GREAT RIVER
ENERGY®

November 9, 2012

**RE: Amendment to Great River Energy Application of August 31, 2012 for
Transmission Facility Certificate of Corridor Compatibility and Route Permit
Prairie Substation to Ramsey Substation 230 kV "GD" Transmission Line
Docket # PU-12-398**

Figure 4-1: Exclusion & Avoidance Areas for Corridor Section & Route ROW Amended

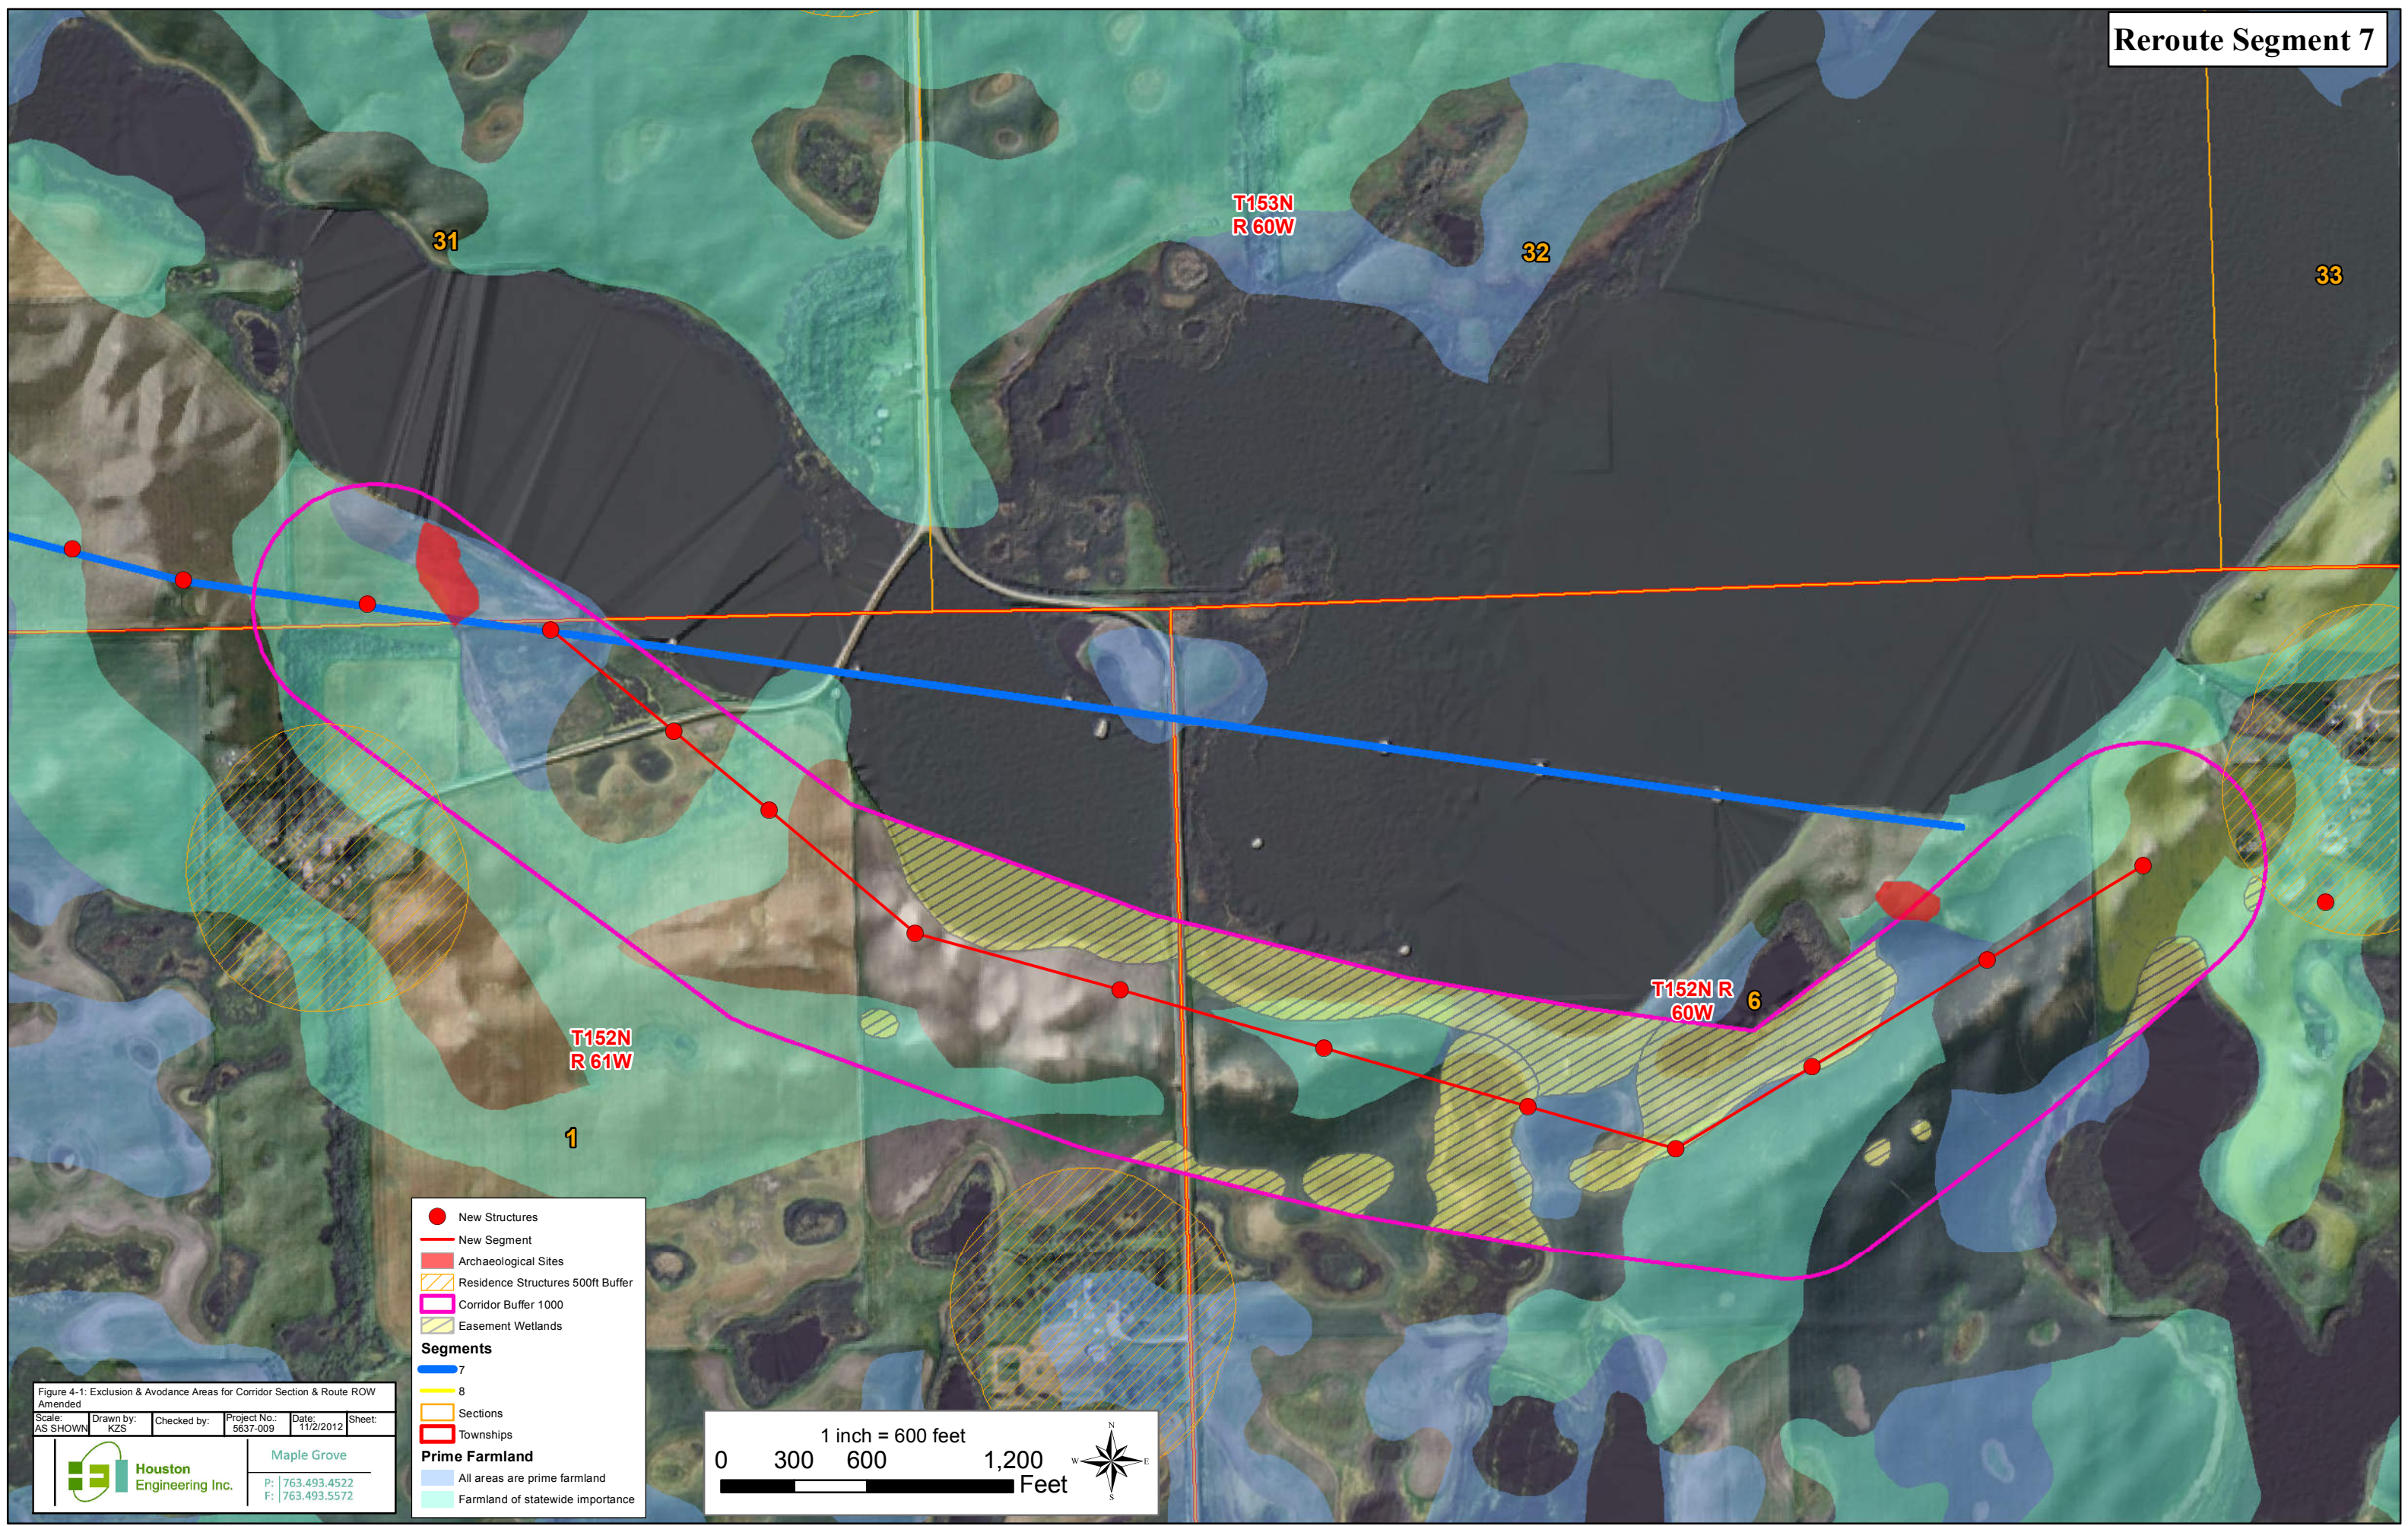
Figures 4-1 and 4-2 (attached) have been amended to represent the updated reroute right-of-way and pole structure locations. The adjustments to the Crary site reroute occurred on the north and eastern sides to avoid prime agricultural land and US Fish and Wildlife Service (USFWS) easement wetlands. The adjustments to the Lakota site reroute occurred as a result of Great River Energy working with landowners and Agency staff to further avoid impacts to prime agriculture land and USFWS easement wetlands.
